PATTERSON LAKE ADDITION

WICHITA, SEDGWICK COUNTY, KANSAS

Re: S/D 95-12 - PATTERSON LAKE ADDITION (Final Plat)

Re: S/D 95-12 PATTERSON LAKE ADDITION (Final Plat)

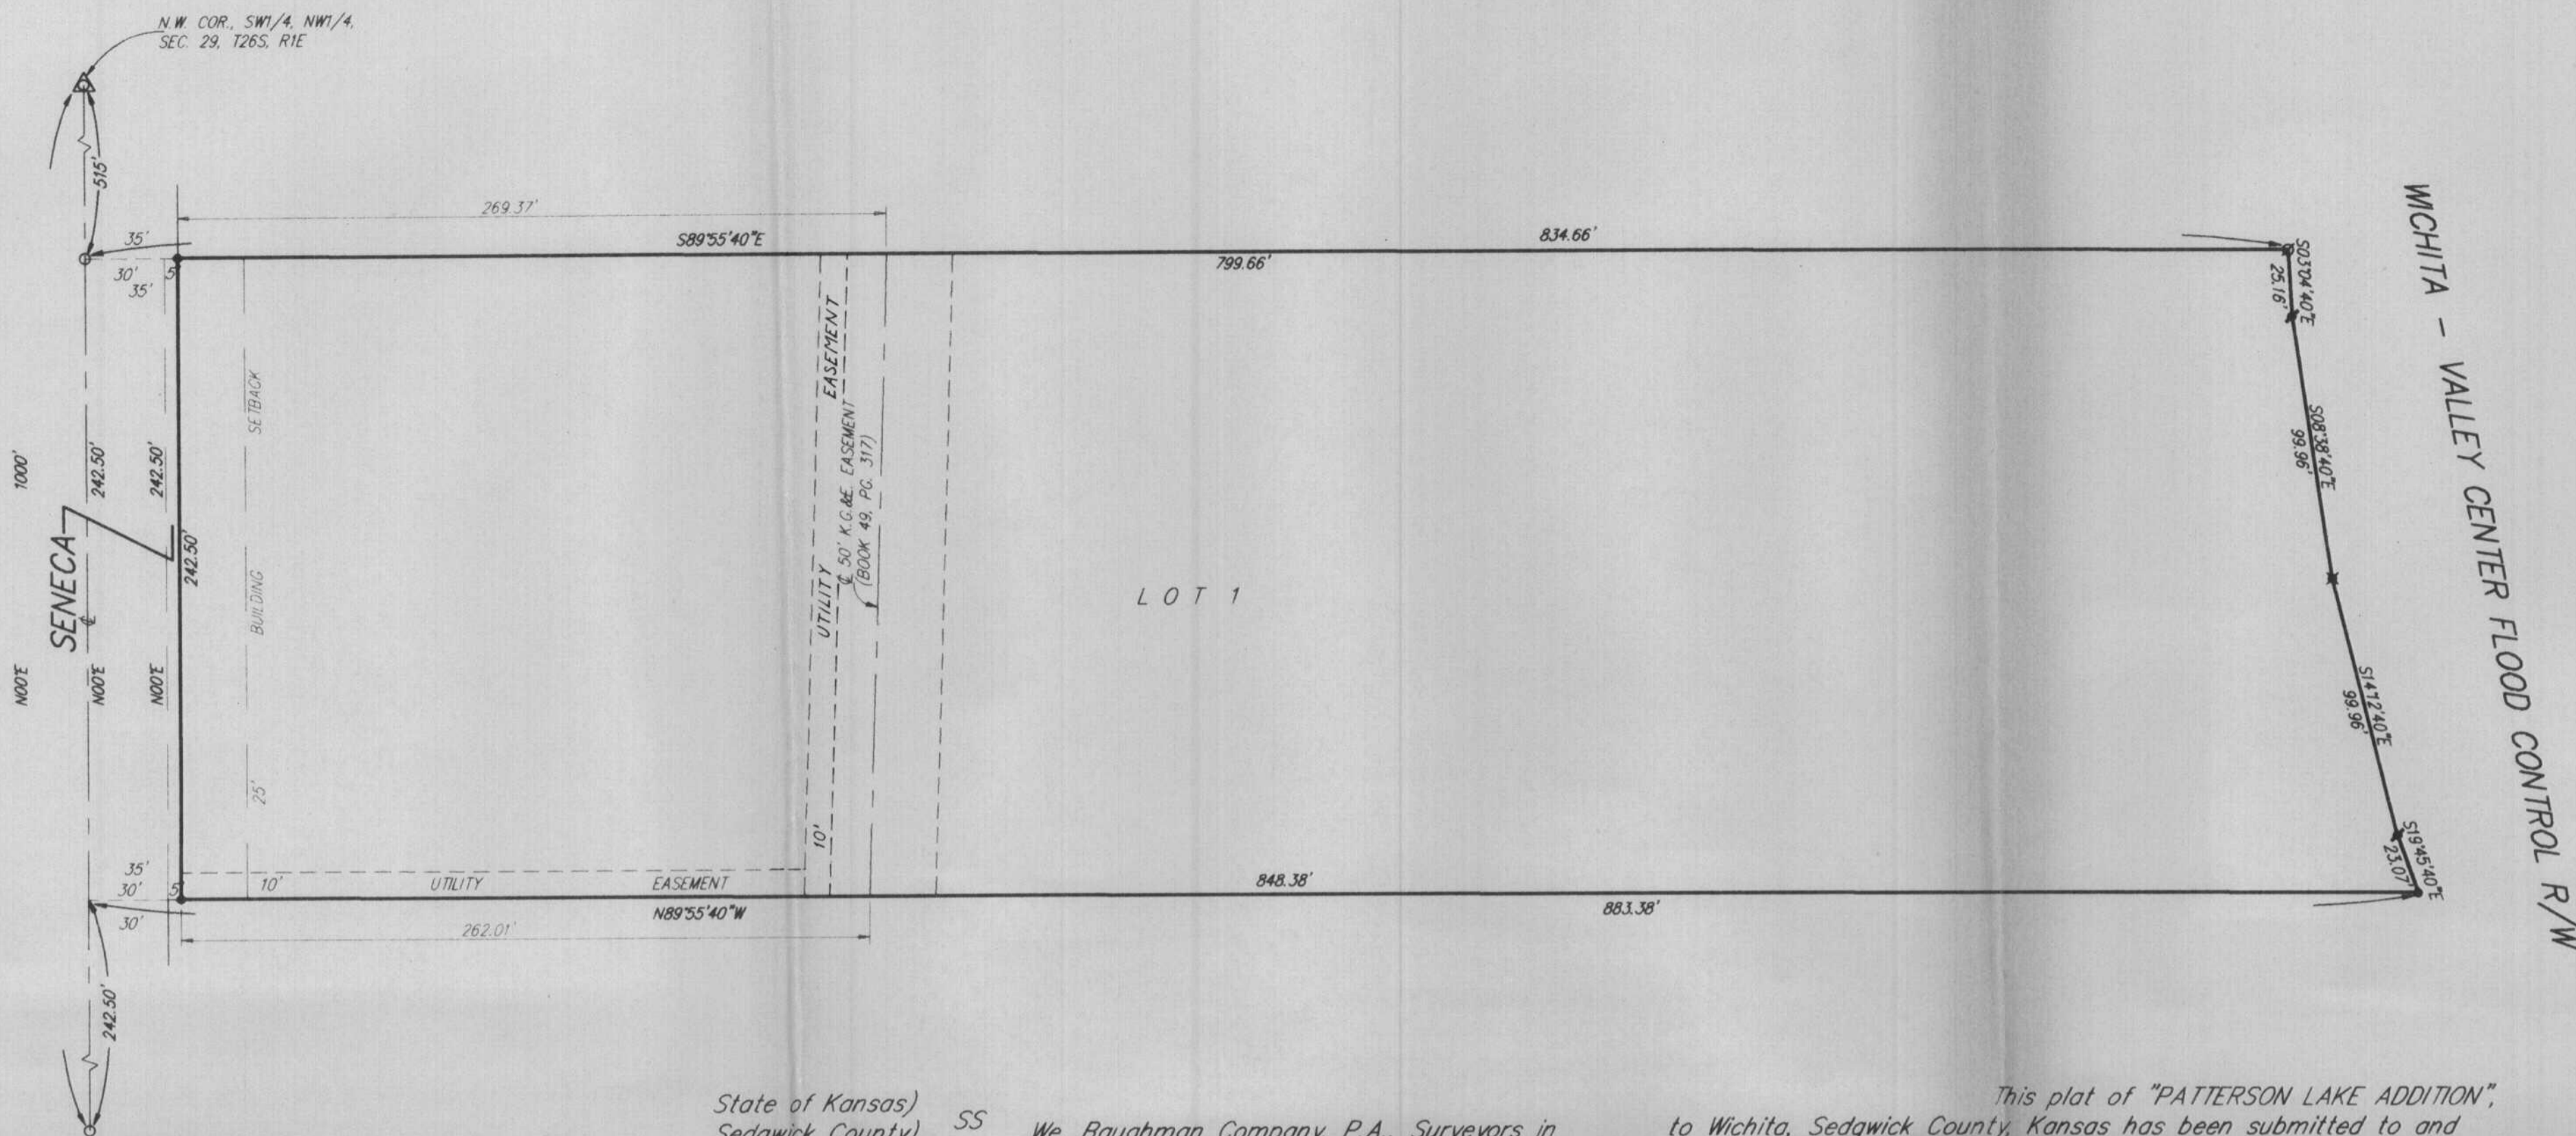
- ~~D.~~ As noted by Engineering minimum building pad elevations shall be established for this site. The final plat tracing shall provide proper documentation and related information (note in plat's text, benchmarks, City datum & MSL, etc.).

- ~~F.~~ Prior to this plat being released for recording, the shed indicated within the 25-foot setback shall be removed. A letter shall be submitted to Planning indicating removal of the shed. The applicant is also advised that the indicated carport at this site could be in violation of the required sideyard setback. If the carport and existing garage remain detached from any

- OK showing*
- ~~G.~~ The final plat shall indicate the utility easements requested by Southwestern Bell which are indicated on the enclosed "marked" copy of the plat.

- D. As noted by Engineering minimum building pad elevations shall be established for this site. The final plat tracing shall provide proper documentation and related information (note in plat's text, benchmarks, City datum & MSL, etc.).

- F. Prior to this plat being released for recording, the shed indicated within the 25-foot setback shall be removed. A letter shall be submitted to Planning indicating removal of the shed. The applicant is also advised that the indicated carport at this site could be in violation of the required sideyard setback. If the carport and existing garage remain detached from any future residence, a three (3) foot sideyard is typically required. If attached to a residence or if the garage were converted to a residence, a six (6) foot sideyard would be needed. Any such violation would require approval of a variance by the BZA.

- G. The final plat shall indicate the utility easements requested by Southwestern Bell which are indicated on the enclosed "marked" copy of the plat.
- H. The applicant shall install or guarantee the installation of all utilities and facilities which are applicable and described in Article 8 of the MAPC Subdivision Regulations. (Water service and fire hydrants required by Article 8 for fire protection shall be as per the direction and approval of the Chief of the Fire Department.)

MINIMUM BUILDING PAD ELEVATION FOR LOWEST OPENING TO STRUCTURES		
LOT	M.S.L.	CITY DATUM
1	1324.0	136.6
